Contract No. HY/2010/08
Central – Wan Chai Bypass – Tunnel (Slip Road 8 Section)
Submission of Additional Mitigation Plan for Slip Road 8 (Revision 7) under condition 2.16 of FEP-10/364/2009/B

**Central – Wan Chai Bypass Tunnel
(Slip Road Section 8)
Contract No. HY/2010/08**

Additional Mitigation Plan for Slip Road 8 under condition 2.16 of FEP- 10/364/2009/B

Revision: 7

SKETCH NO. 60095653/T2/SK0721D SCALE 1:500(A3)

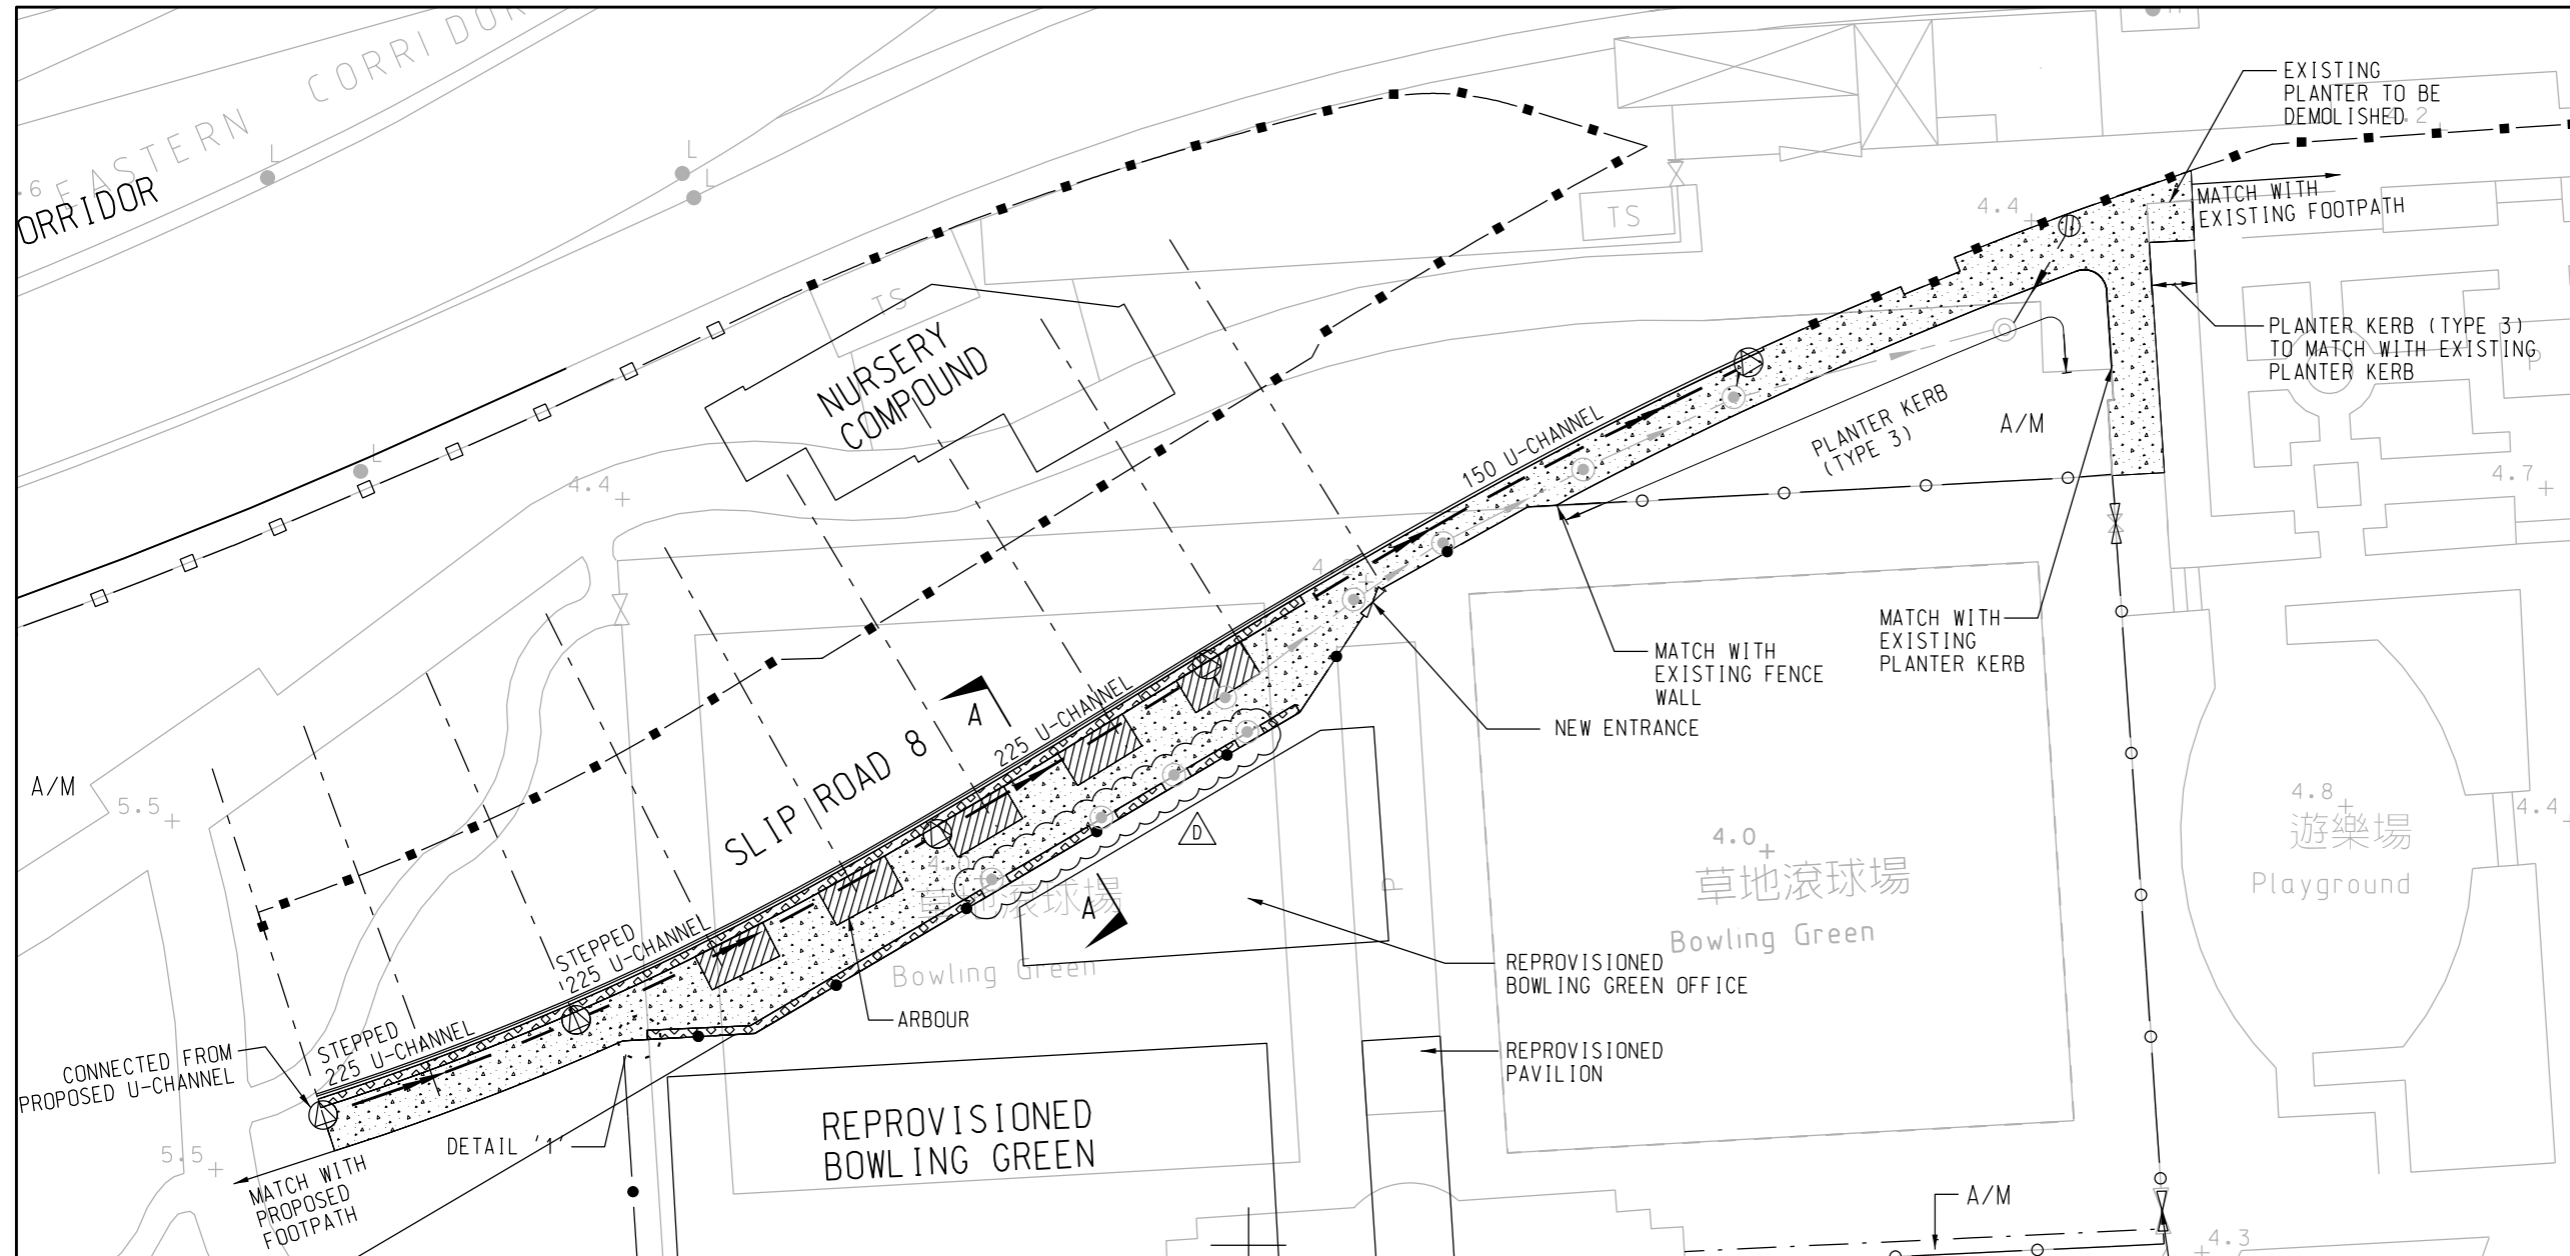
Replacement of Shrub Planting with Bamboo Planting at the Additional Walkway

I refer to the joint site inspection on 15 October 2019 amongst D. C. Member Dr. Jennifer Chow, representatives from VPMO, CSHK and AECOM/RSS, concerning the replacement of shrub planting [*Duranta repens* 'golden' (DRG) 金連翹] with bamboo planting [*Bambusa vulgaris* cv Wamin (BVW) 大佛肚竹] at the Additional Walkway as shown in the attached Sketch No. 60095653/T2/SK0750A.

It was recorded that both Dr. Chow and VPMO had no adverse comment to the replacement planting. As previously agreed, the completion date of the Establishment Period for the concerned planting remains at 29 January 2020.

SKETCH NO. 60095653/T2/SK0750B SCALE 1:250(A3)

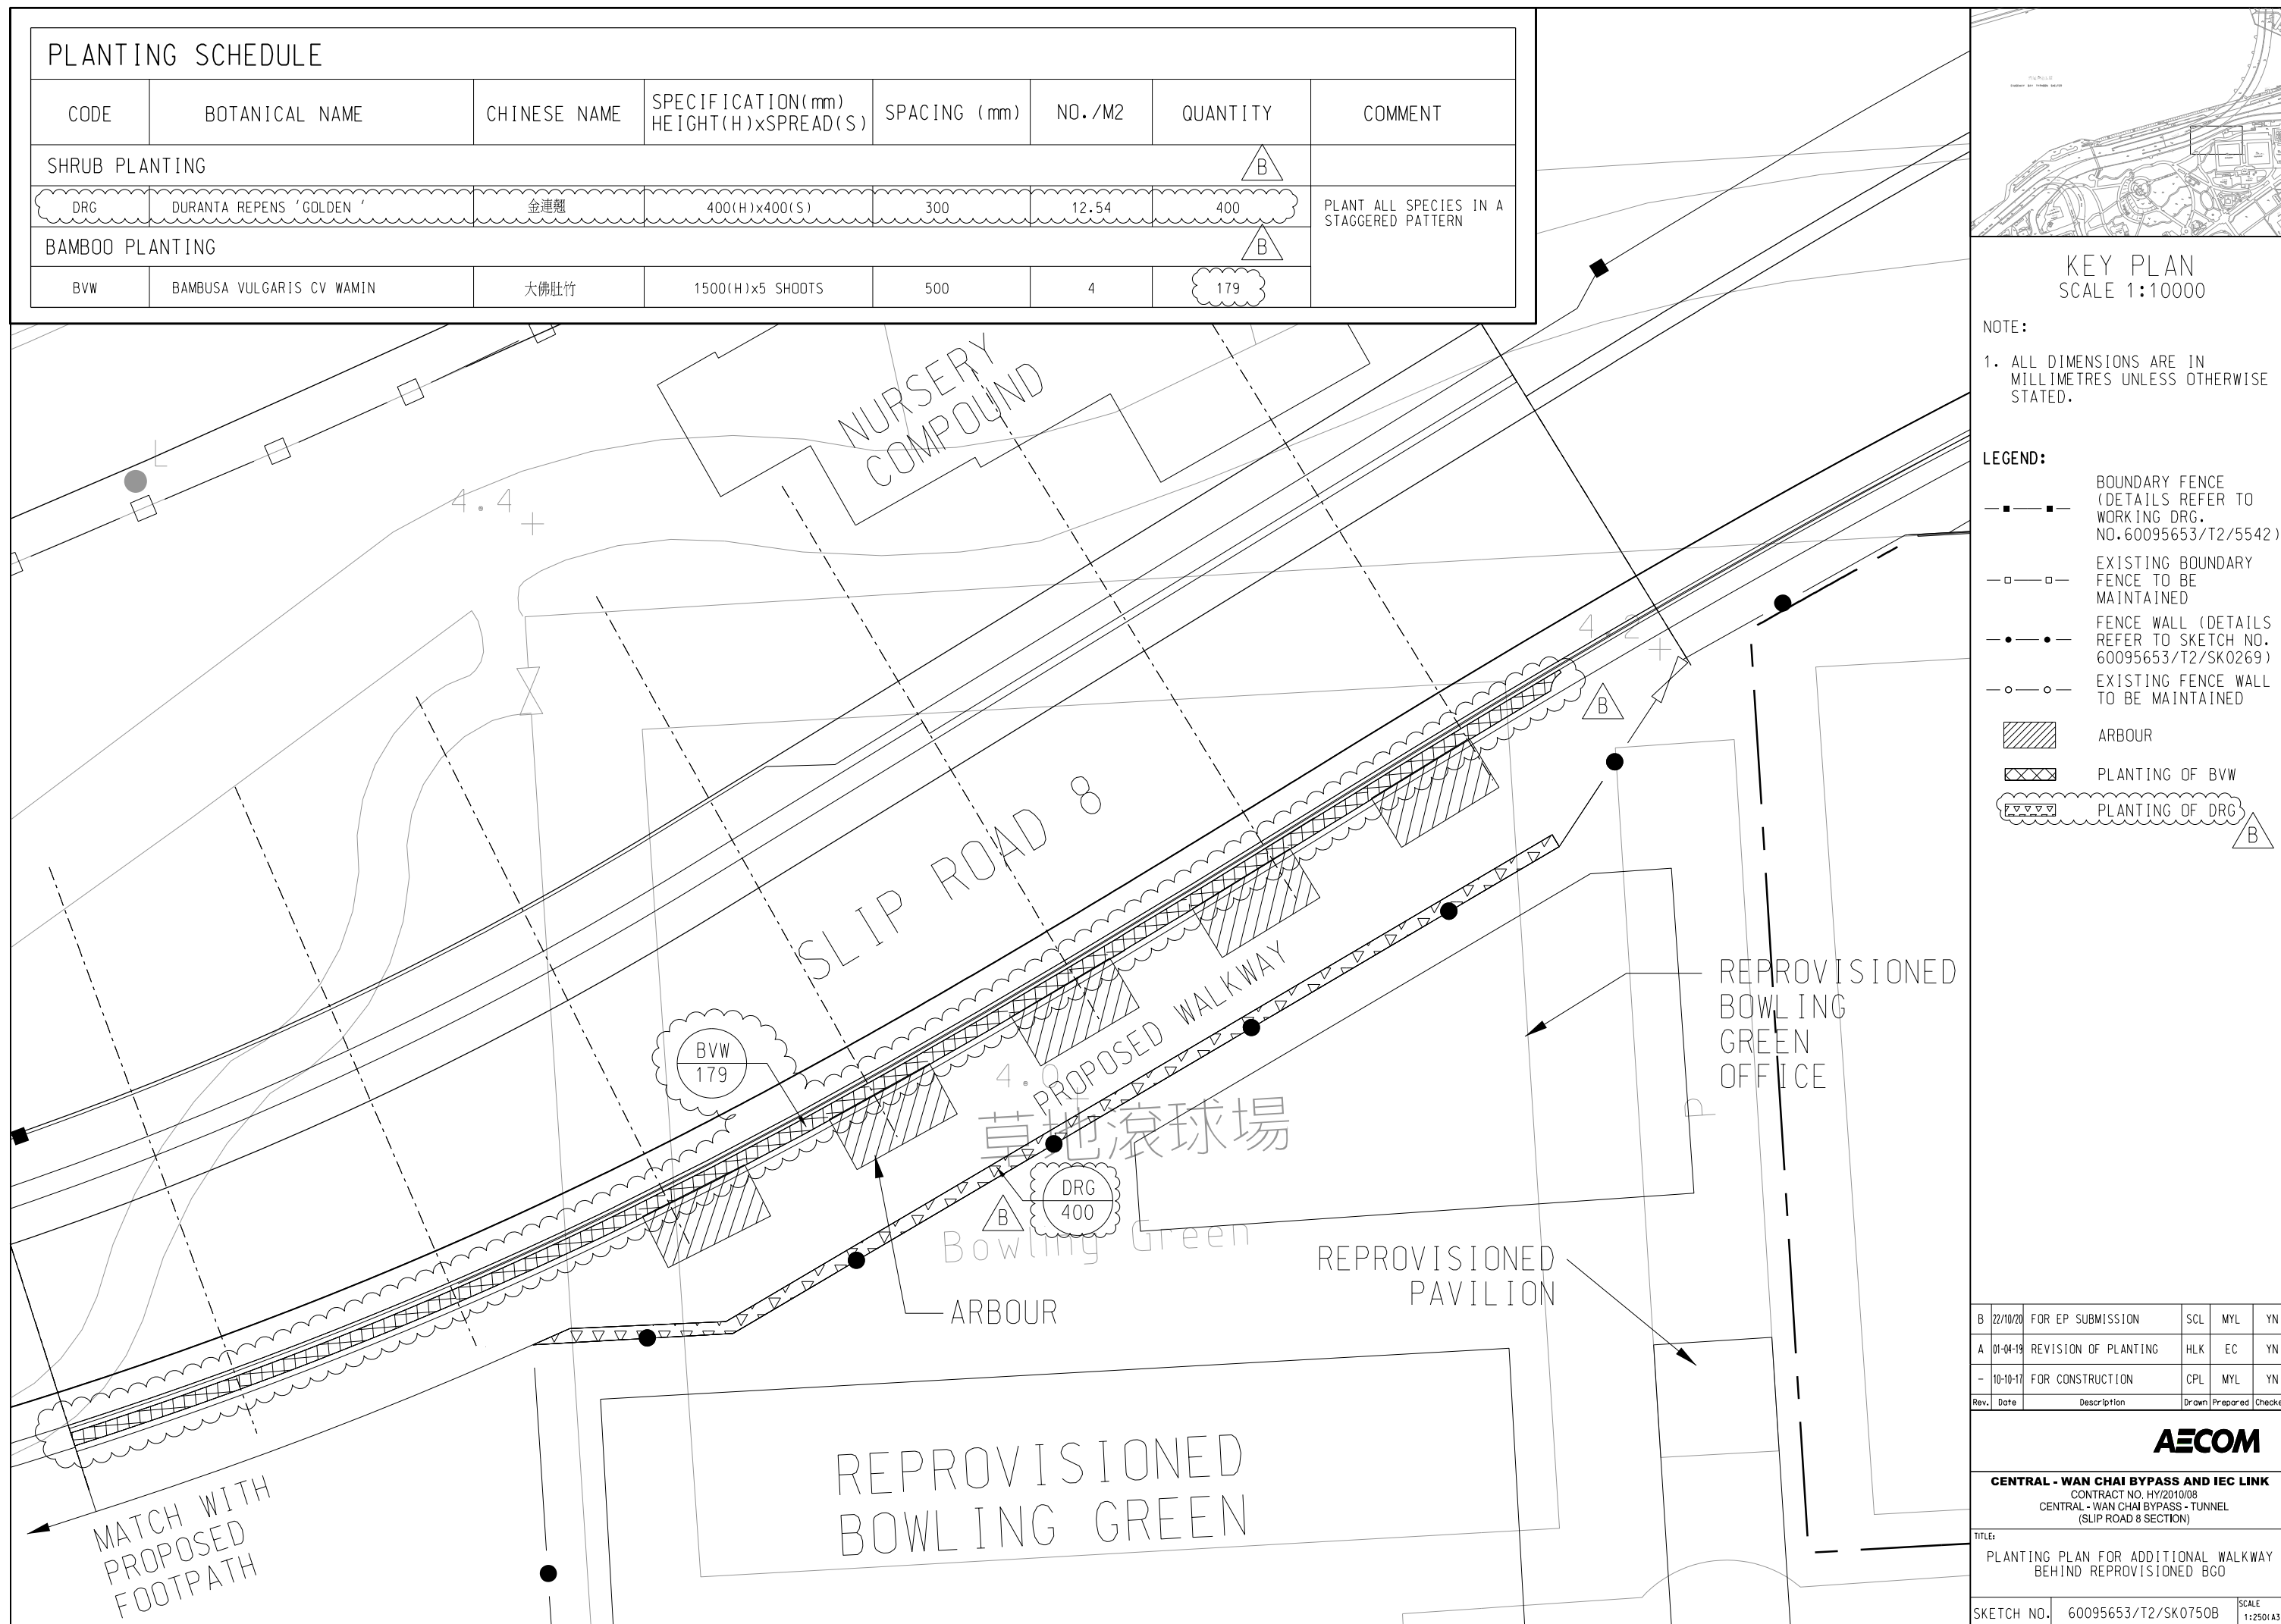
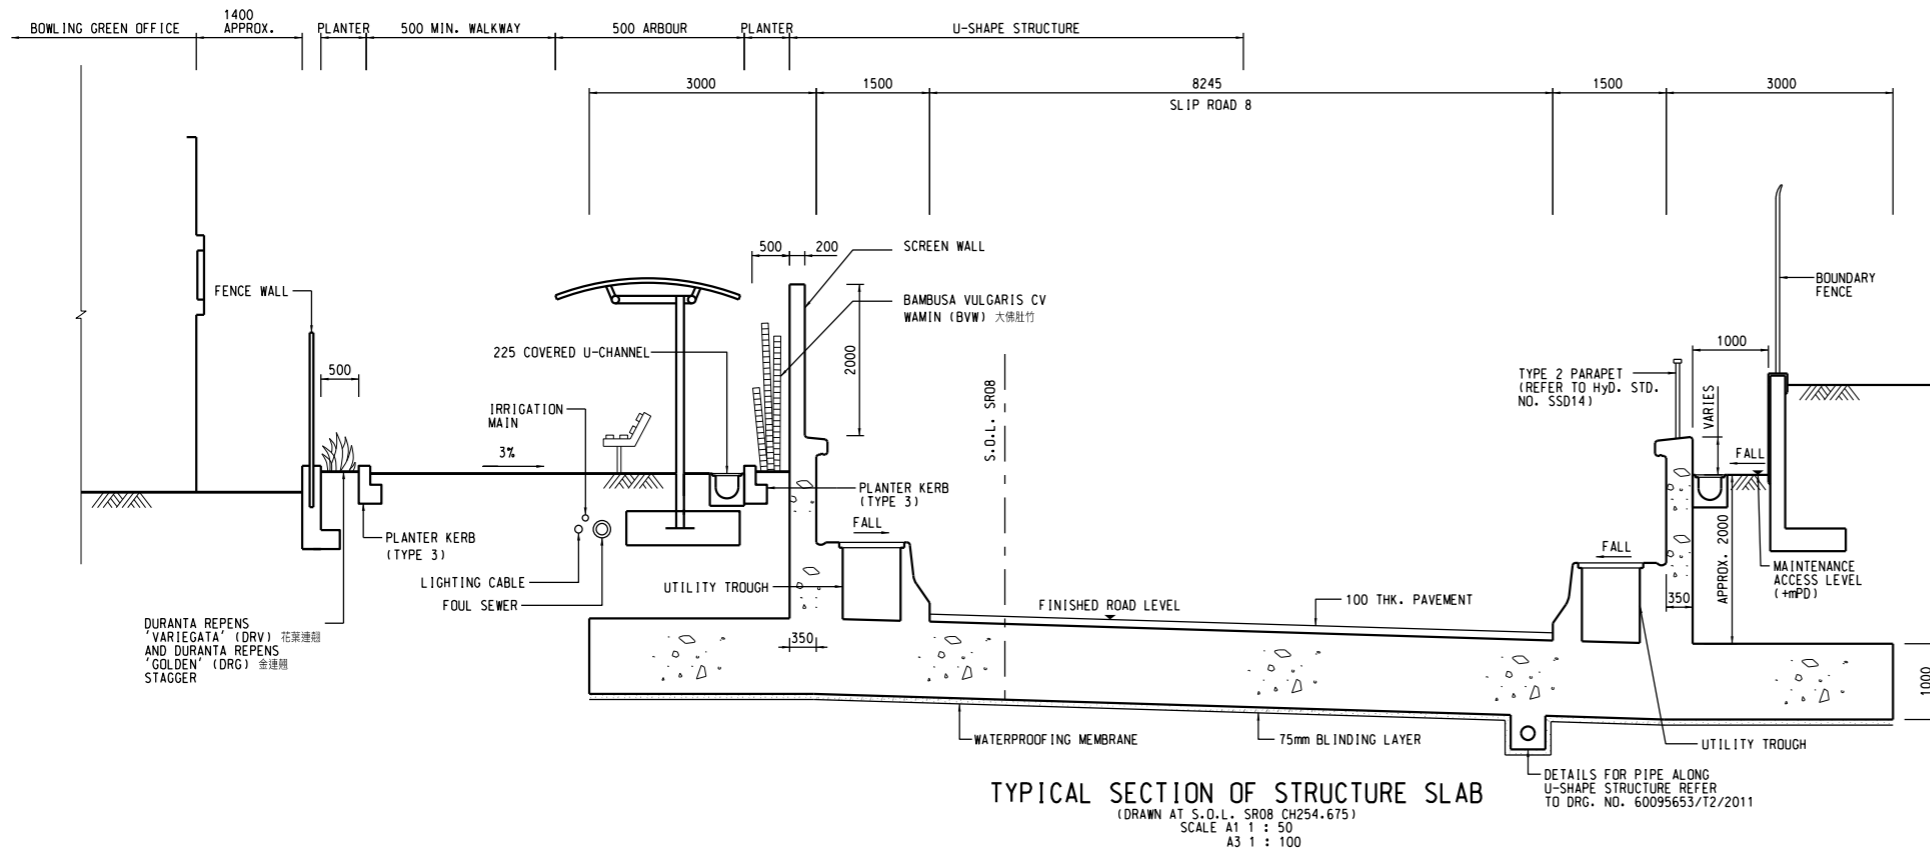
EPD's observation / comment via fax dated 17 June 2020	Responses
Wan Chai Development Phase II – Central-Wan Chai Bypass Tunnel (Slip Road Section 8) FEP Condition 2.16: Additional Mitigation Plan (Revision 6)	
i) However, shrub species i.e. <i>Duranta repens</i> 'Variegata' (DRV)/ <i>Duranta repens</i> 'Golden' (DRG) is found still missing in the planting schedule in the revised drawing title 'Planting Plan For additional Walkway Behind Reprovisioned BGO(Sketch no. 60095653/T2/SK0750B) in the current submission (rev.6). As such, our previous comment dated 18.5.2020 is still valid. Please refer to the comments marked up in the concerned drawing as attached.	Appendix C Drawing revised

As discussed in the VPMO Meeting yesterday, please advise whether you have any comment on the proposed planting plan for the additional walkway as shown on the attached Sketch No. SK0750.

Please be advised that we have no adverse comment for the proposed planting plan for the additional walkway and the proposed location of 12 nos. transplanting trees.

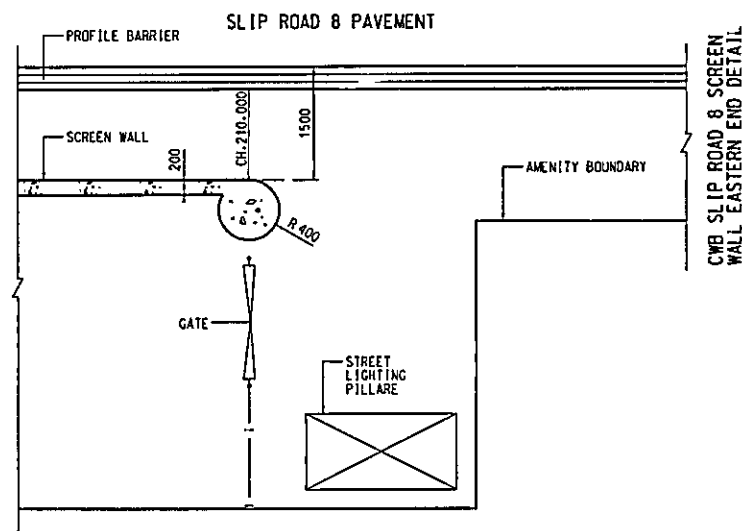
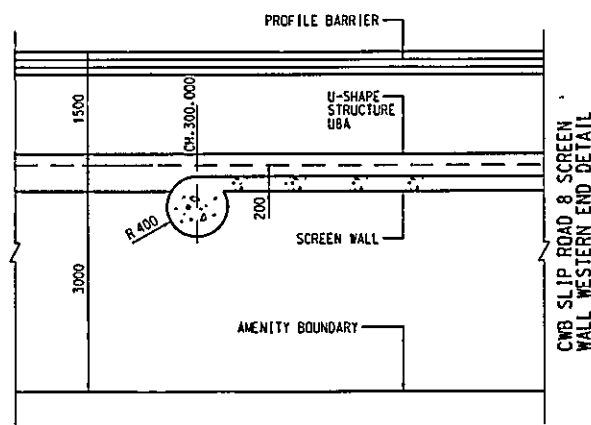
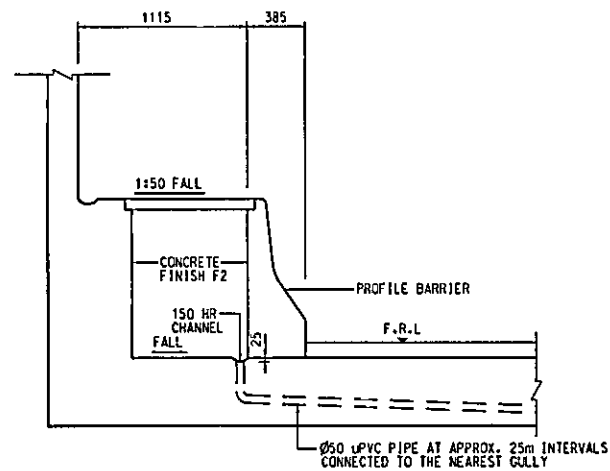
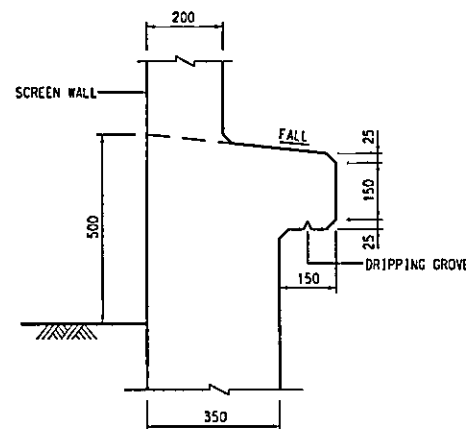
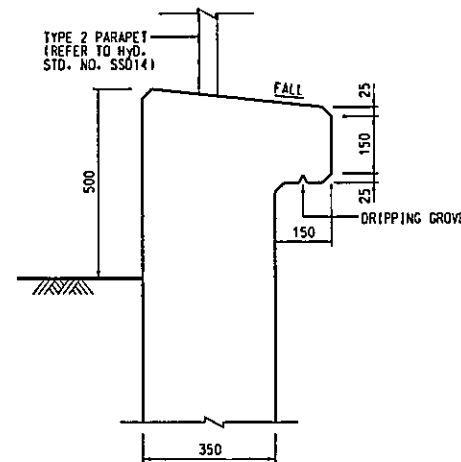
Deletion of Wall Pattern on Screen Wall

In accordance with GCC Clause 6(3), i enclose Sketch No. 60095653/T2/SK0760 showing the deletion of the wall pattern on the Screen Wall.
